[01/22/2021]

ADDENDUM NO. #1  
City of Troy  
Troy Pedestrian Paths

<b>SCHEDULES</b>		F.A. RTE.	SECTION	COUNTY	TOTAL SHEETS	SHEET NO.
SCALE:	SHEET NO. 1 OF 1 SHEETS	STA.	TO STA.	MADISON	86	5

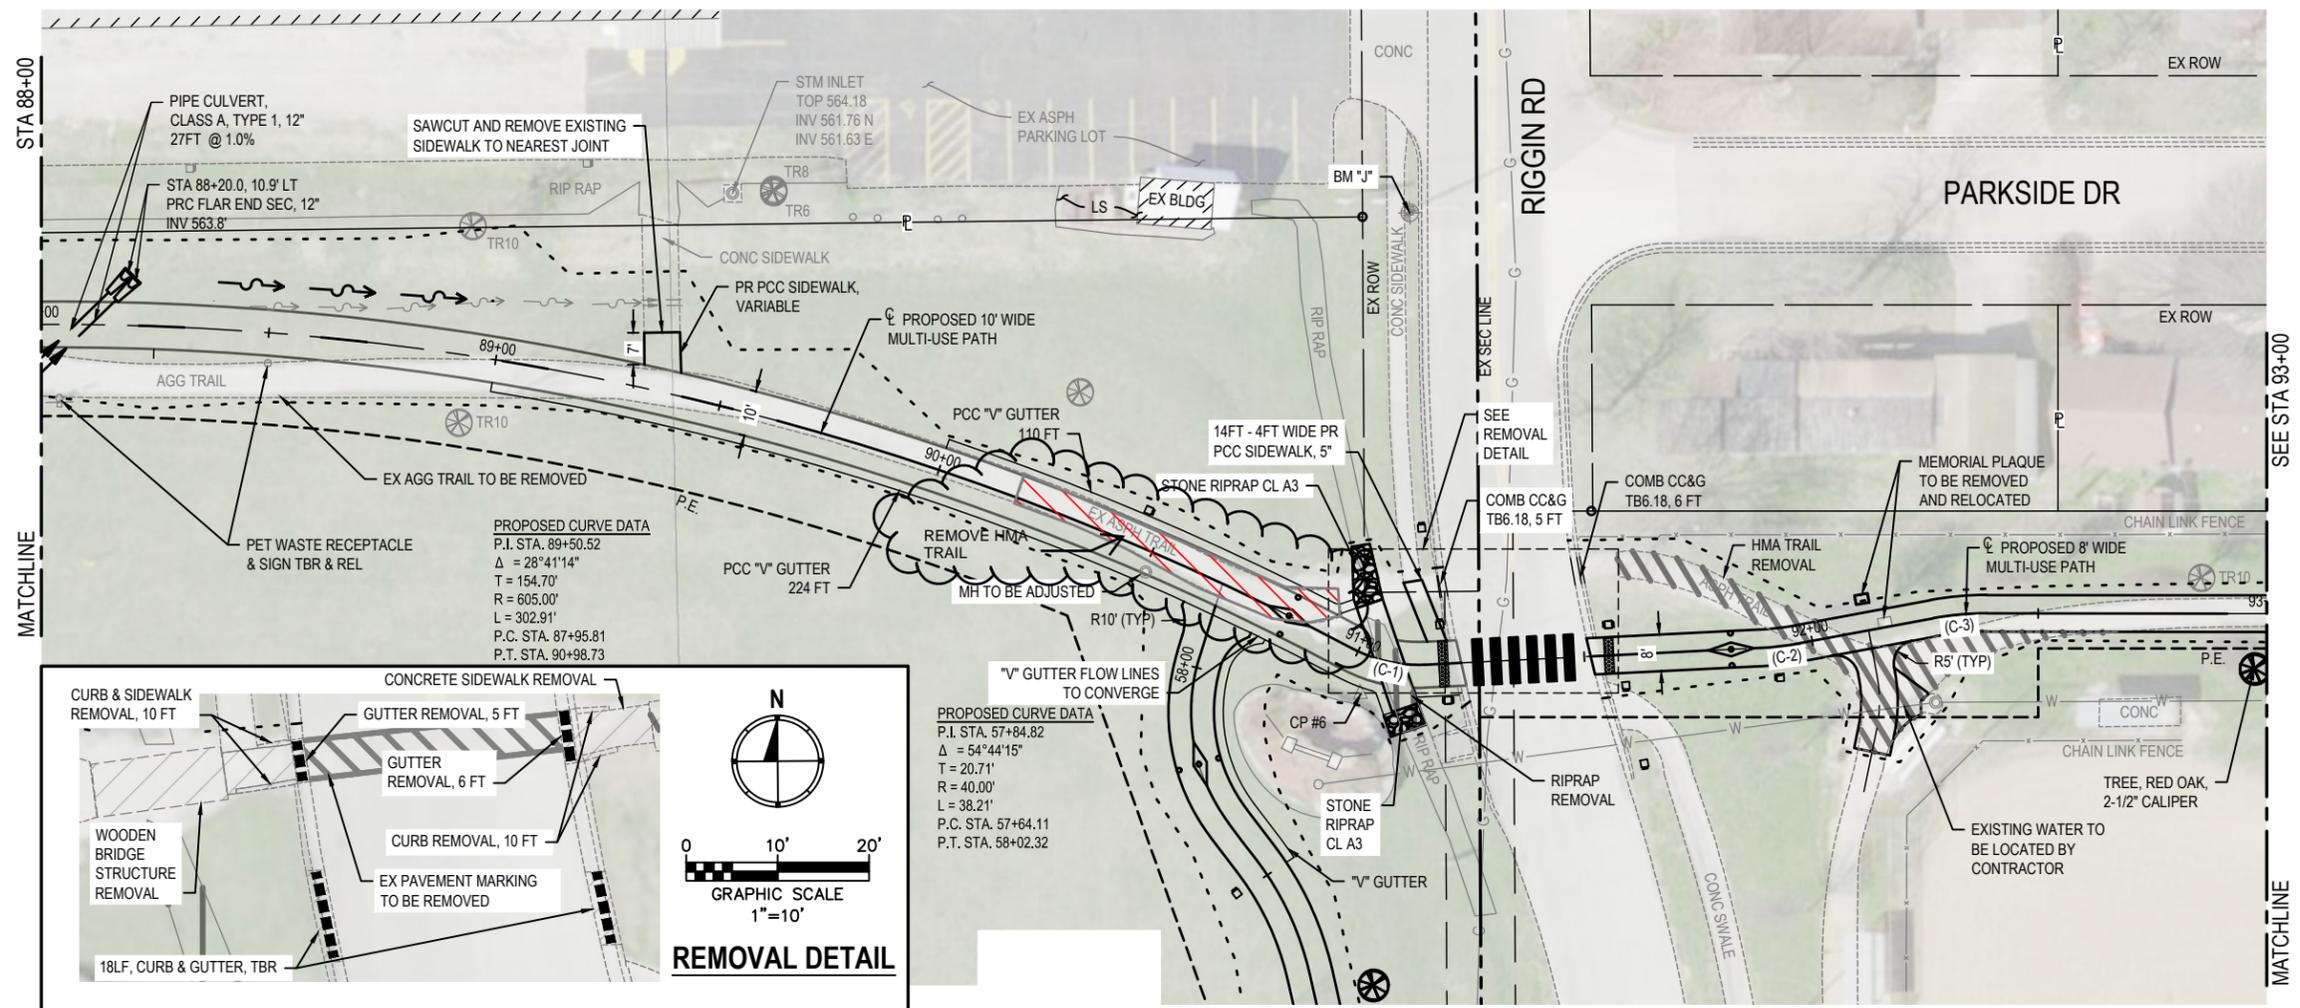
4. Pvt removal is shown on the schedule and drawings in the area of 91-92+XX and 100+25 area. We just walked the job and found asphalt from 90+00 to 100+50 continuous. This removal will further reduce the available embankment material onsite causing a need for additional furnished excavation. Can you address?

7. The earth excavation schedule shows a cut of 1460 and a fill of 1890, leaving a shrunk embankment shortage of 648 CY. The cross sections do not differentiate final grade versus the 4" layer of topsoil to be placed. Is it the intent of the designer that the 6493 sy of topsoil 4" (721 cy) makes up the embankment shortage from the earth excavation pay item, or is it expected that the contractor will need 648 cy plus the 4" of topsoil?

Answer: There is 500 sf of sidewalk removal at the south end of the project which was not included in the quantities.

Answer: Earthwork was calculated to the final surface grade. The 4" topsoil layer was included in the earthwork quantities, and was intended to makes up a portion of the embankment shortage as furnished excavation. Delete the Furnished Excavation quantity. The embankment shortage will be furnished as the 4" topsoil layer.

<b>RAMP INTERSECTION DETAILS</b>	
SCALE:	SHEET NO. 1 OF 5 SHEETS STA. TO STA.

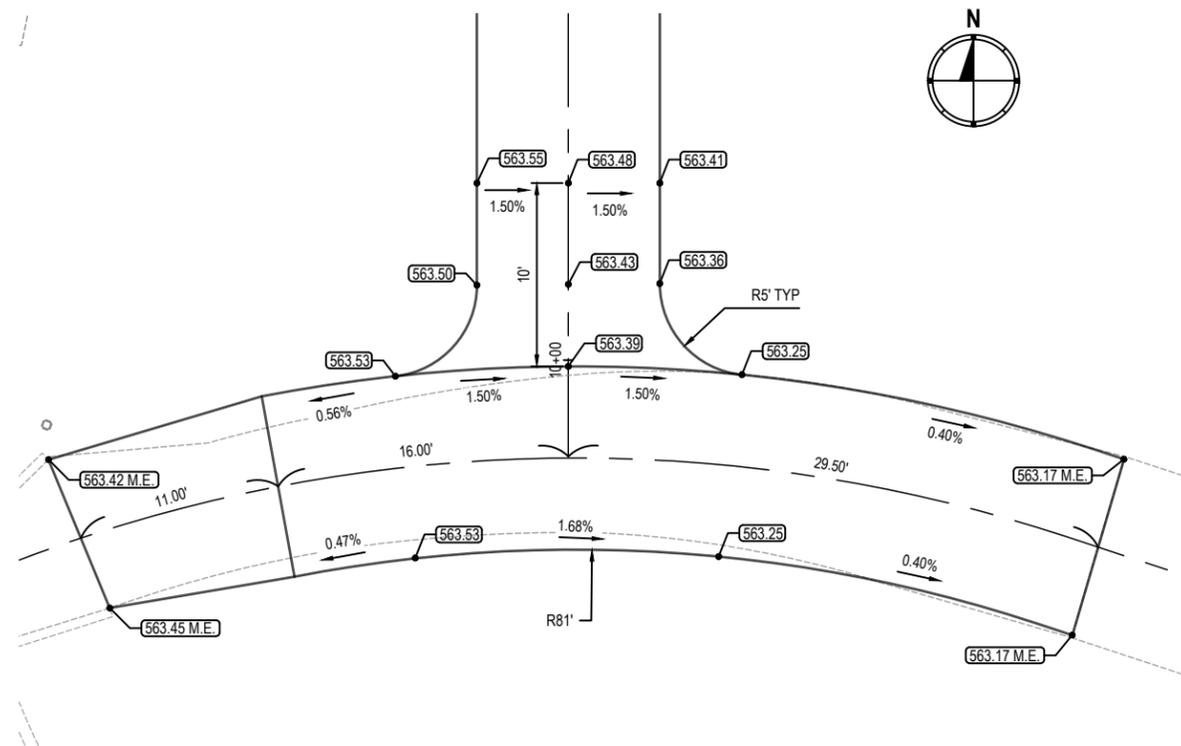
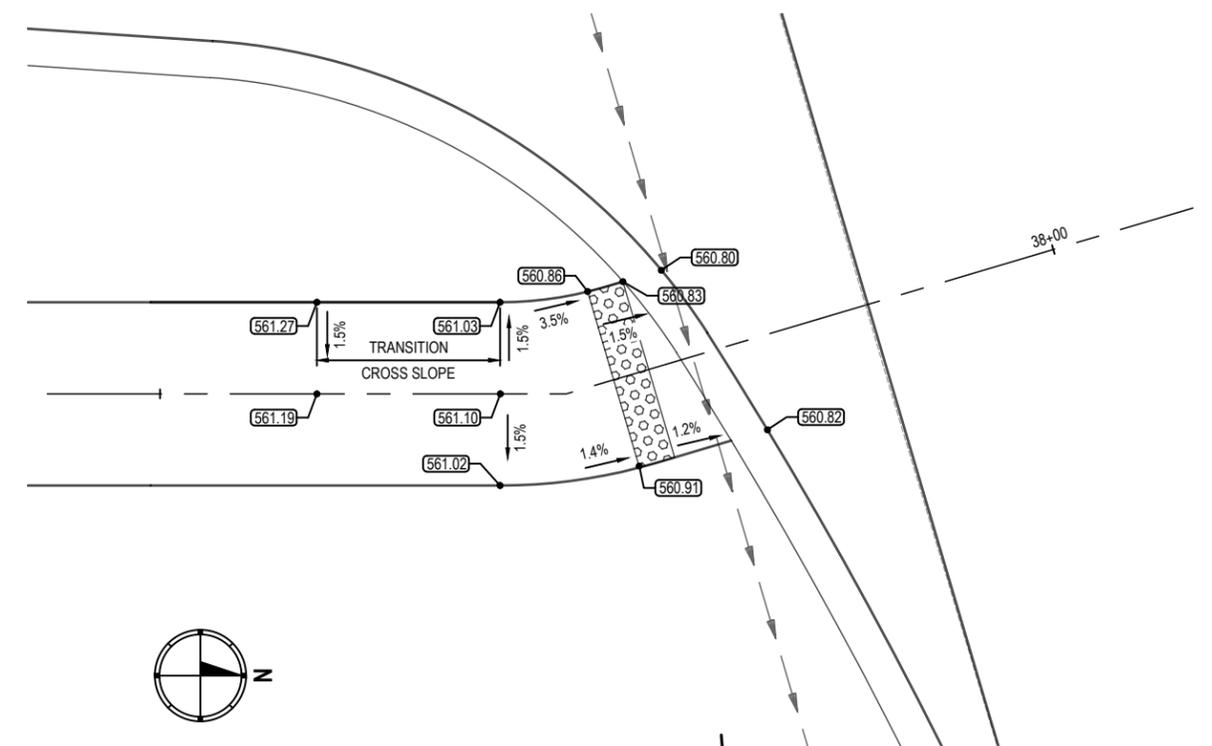
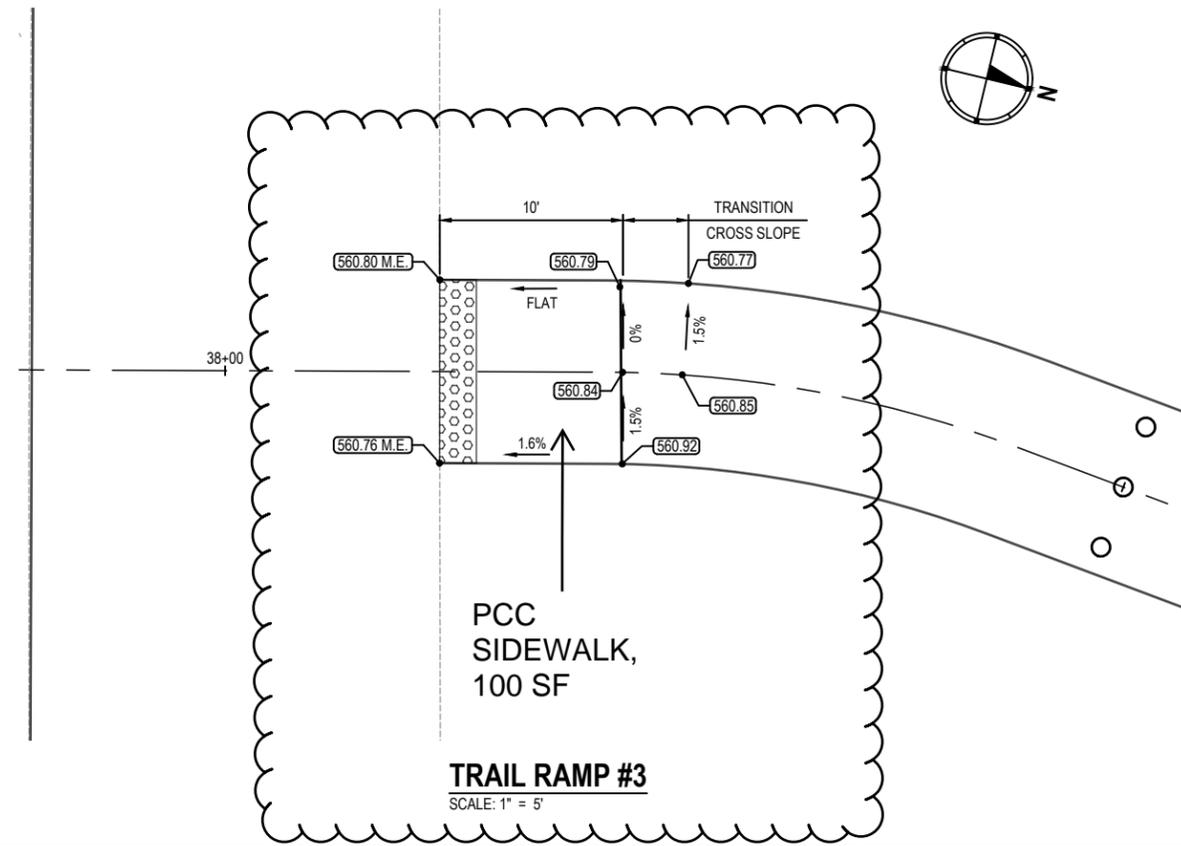
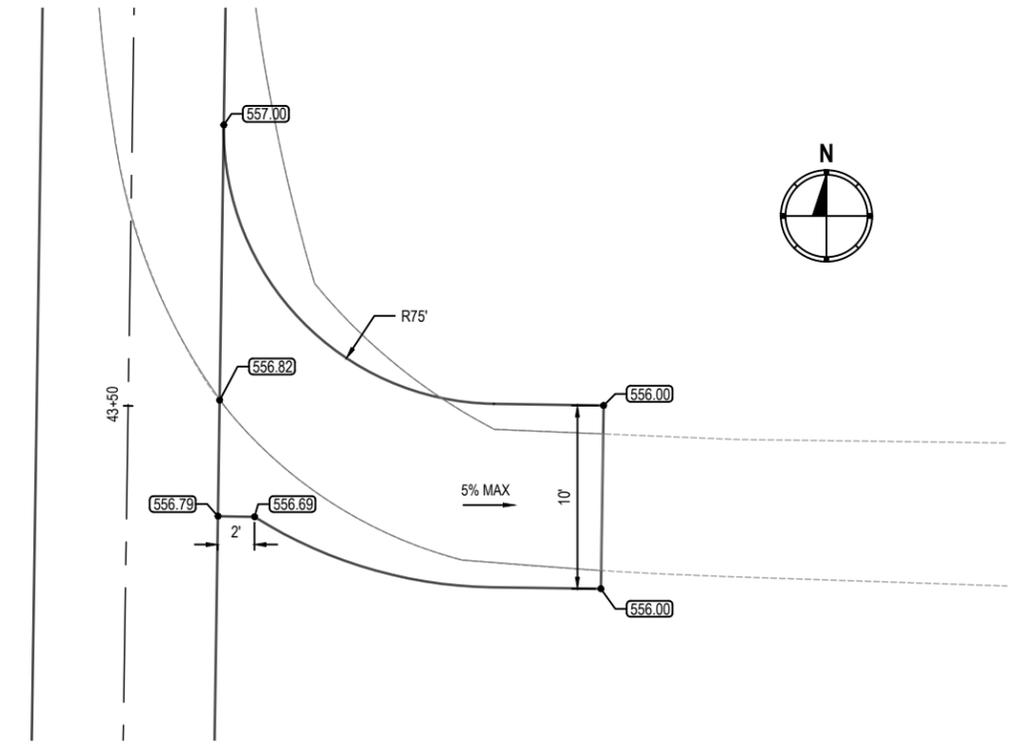
1. There are several places on the project where there is a call out for detectable warnings in the schedule, but no concrete sidewalk at those areas. Do you intend to have the detectable warnings surface applied to asphalt, and if so, it says the detectables are to be black in color, but elsewhere says they should have a “visual contrast with the adjoining concrete surface.” Can you review and advise?

Answer: Ramps are intended to be concrete. Sheets 28-31 have been revised to clarify. Adjust quantities to add 936 sy of PCC sidewalk and reduce HMA Surface Course by 17 tons.
